REPORT NO. (1) W3-6238

NONCONFORMANCE REPORT

SUBJECT LOUISIANA POWER & LIGHT COMPANY
WATERFORD STEAM ELECTRIC STATION
1983-1165 MW INSTALLATION - UNIT NO. 3
NONCONFORMANCE REPORT

TYP. WELD DET. TO
CONDENSATE POT

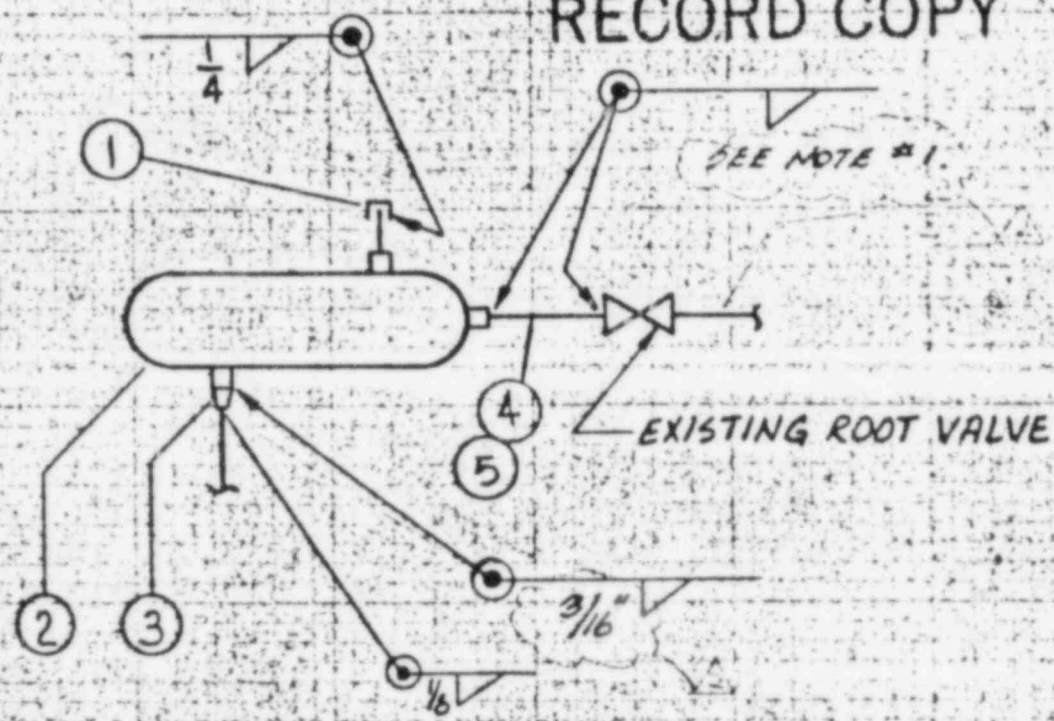
2. DESCRIPTION OF NONCONFORMANCE FW 49, LOCATED BETWEEN CONDENSATE PCT SW 1A2 AND VALVE 2 ST-V 609-9 IS REQUIRED TO HAVE A 5/16" WELD. THE Scribed ID OF THE WELDER ON FW 49 IS M-198. THE WELD DATA SHEET SHOWS A CROSS OUT OF 198 & M-51 IS INSERTED IN ITS PLACE. RESEARCH OF THE FMWA'S TURN UP BUT ONE WELDER, M-51 AS HAVING DRAWN ROD ON THAT LINE FOR THAT DATE. IT INDICATES THAT M-51 DID THE WELDING EVEN THOUGH THE SCRIBE MARKS DO NOT INDICATE SO. THERE IS ONE PT WHICH ACCEPTS THE WELD. AN ATTEMPT WAS MADE TO VERIFY THE WELD SIZE BUT THE CLOSE TO CORNER OF THE INSTALLATION IS PROHIBITIVE OF THE REQUIRED ROOM TO USE THE GAUGE. ATTACHED ARE FILM# 36866, PT# 16967, ZII REPORT & WELD DATA FOR THE WELD. THE WELD AT A GUESS IS ABOUT THE REQUIRED SIZE.

Reinspection of FW#49 to verify weld size.
FW#49 found to be undersize. Measurements are
Ver. Leg measurement to be $3/8"$ Hery. Leg $1/4"$, weld
is undersize by $1/8"$ (SEE below)

10. REMARKS 6/23/83 THEREFORE LIGHTLY BUFF OUT M-198 AND REELECT M-51 AT PW#49. DOCUMENT SAME. 3. DUBM/ DOCUMENTED SIZE OF PW#49 TO ENGINEERING FOR EVALUATION AND FINAL DISPOSITION OF THIS NCR. 26/83 PER ATTACHED FORM-211 WELD IS UNDER 1/16". BUILD UP PW#49 TO 5/16". REMOVE
